OUT20/15537

**Stockton Sand Quarry (SSD 9490)  
Response to Submissions**

### Detailed advice to DPIE - Planning & Assessment regarding the Stockton Sand Quarry (SSD 9490) RTS

Figure 1: Acid sulfate soil probability

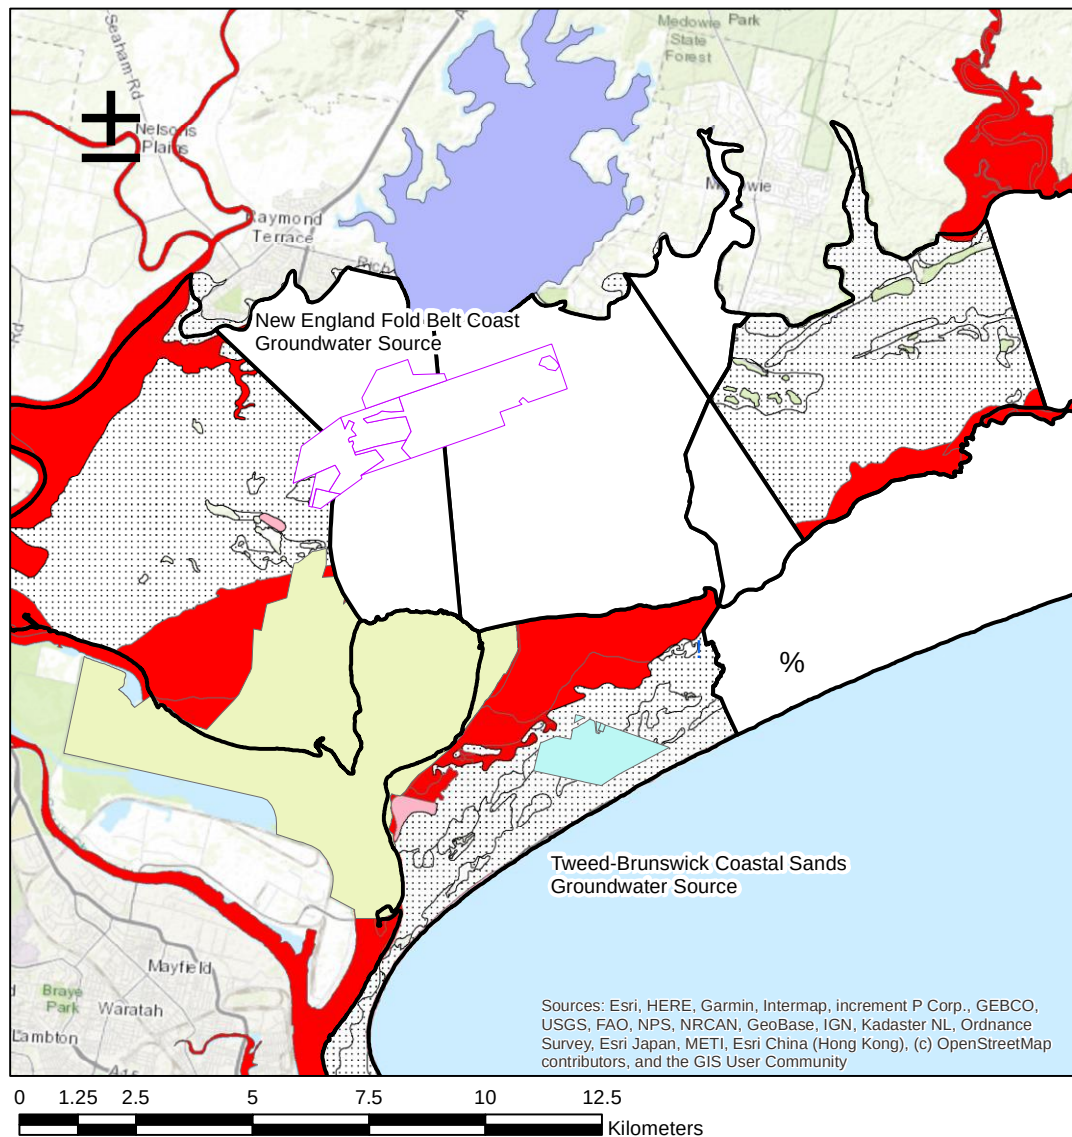
Figure 1 (in Attachment B) presents the acid sulfate soil probability mapping identifying that both the RZM site and Boral's proposed site occur within mapped low probability acid sulfate soil areas. Both sites have a very similar geological and soil landscape setting comprising aeolian dune and sandplain deposits. Both sites reported similar vertical lithological profiles with light brown and yellow sands transitioning to grey sands at depth. The pre-mining water quality for both sites reported quite low background trace metal concentration, albeit the RZM investigation was more comprehensive.

Both RZM and Boral proposals made/make the assumption that natural buffering will neutralise the risk of pyrite oxidation and risk of elevated metal concentrations. RZM was unable to mitigate the decline in the aquifers beneficial use with serious impacts to Hunter Water Corporation (HWC) asset and water strategy. The RZM Management Plan alerts the reader to potential
